Service Information

Category T	Repair Guidance	Ref. No. R059/17	Page 1 of 5
Coverage <input type="checkbox"/> Distributor only <input checked="" type="checkbox"/> Please inform your dealers		Date Issued August 22, 2017	
Please convey this information to your <input type="checkbox"/> Director <input checked="" type="checkbox"/> General Manager <input checked="" type="checkbox"/> Warranty Dept. <input checked="" type="checkbox"/> Parts Dept. <input checked="" type="checkbox"/> Training Dept. <input checked="" type="checkbox"/> Field Rep.		Date Revised	
Applicable Model MX-5 (ND) with Bose® Speakers		Applicable Countries and/or Vehicle Specifications Worldwide

Subject: Buzzing from Driver and/or Passenger-side Headrest Speaker(s) when playing radio or other audio media

DRIVER SIDE HEADREST PAD
- after removing Seat Back Trim-

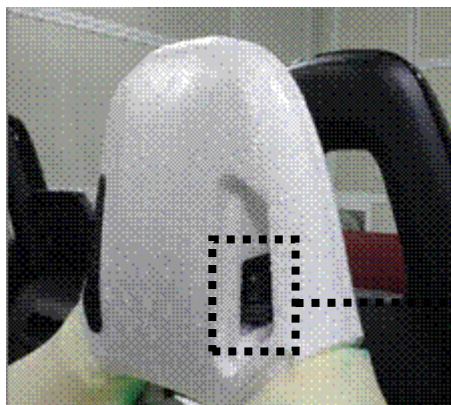
The upper part of the speaker cone is interfering with the headrest pad causing buzzing.

The shape of the headrest pad will be changed to assure sufficient clearance between the speaker and the headrest pad.

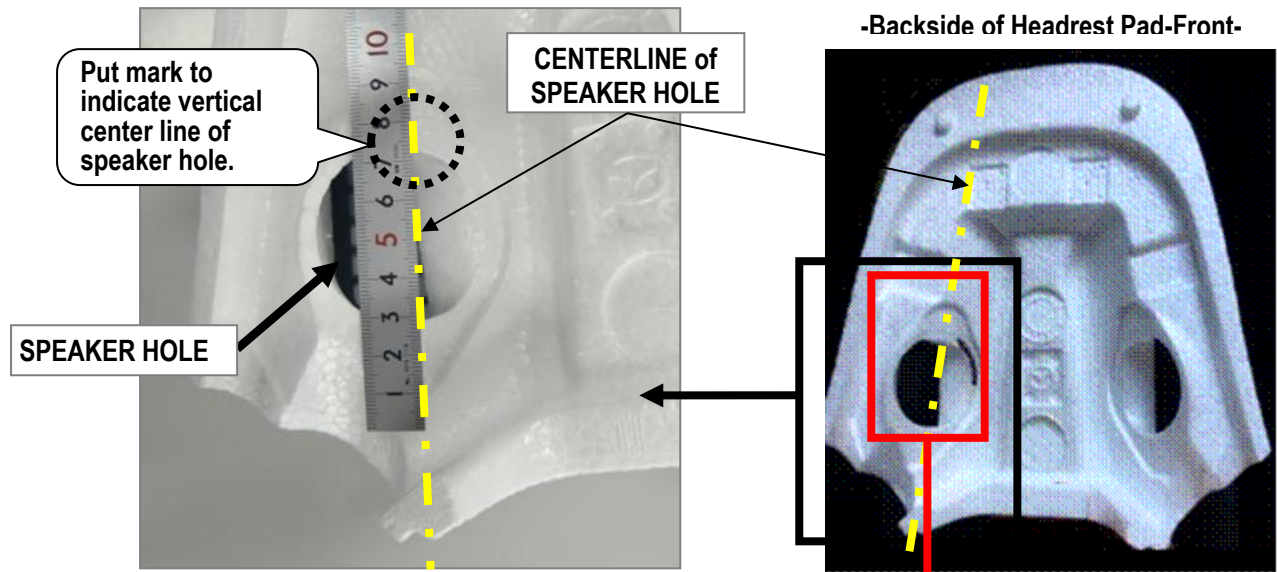
1) Using a felt tip pen, mark an outline of the area to be cut off as shown.

1.1. Put a mark on the headrest pad to identify the vertical centerline of the speaker hole.

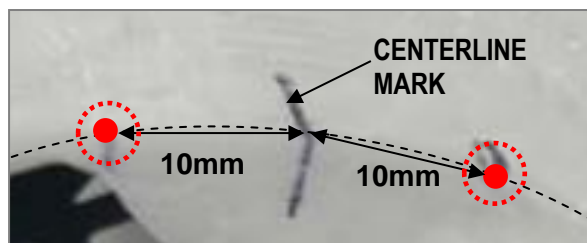
1.2. Put two position marks 10 mm away from the vertical centerline of the speaker hole.

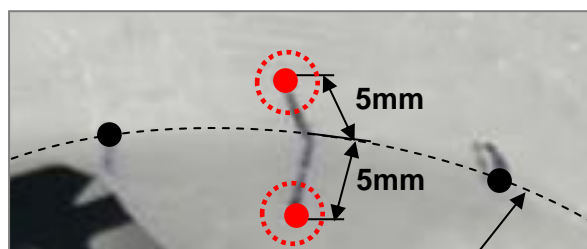
1.3. Put two position marks 5 mm away from the speaker hole edge line..

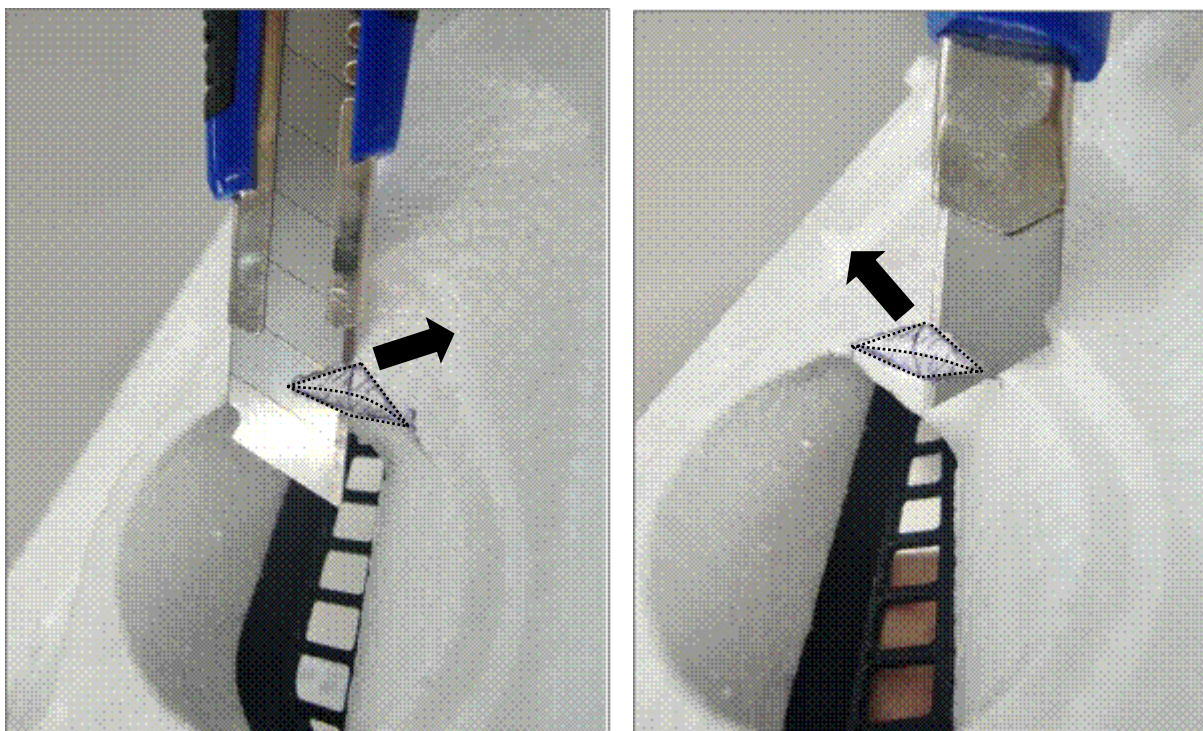
1.4. Mark four cut lines as shown.

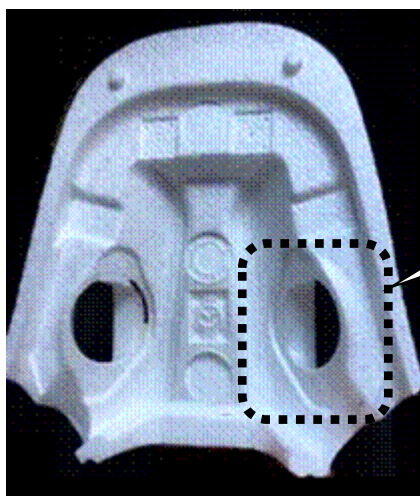
2) Using a sharp box knife, cut off the marked area from the headrest pad as shown.

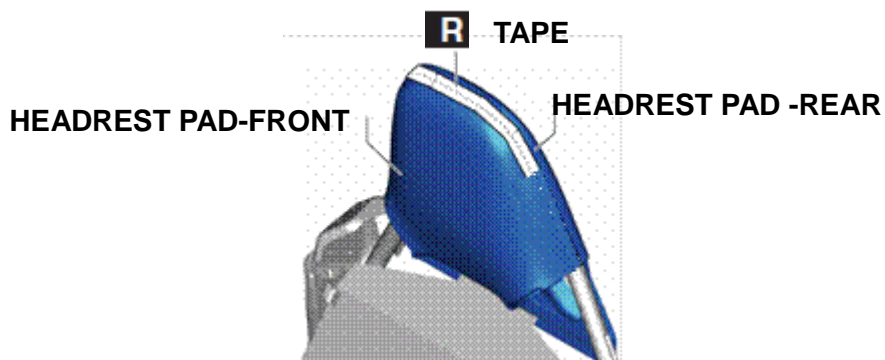
3) Using the same procedure of the step 1) and 2), cut off the headrest pad for the other side speaker.

Cut off other side using the same procedure.
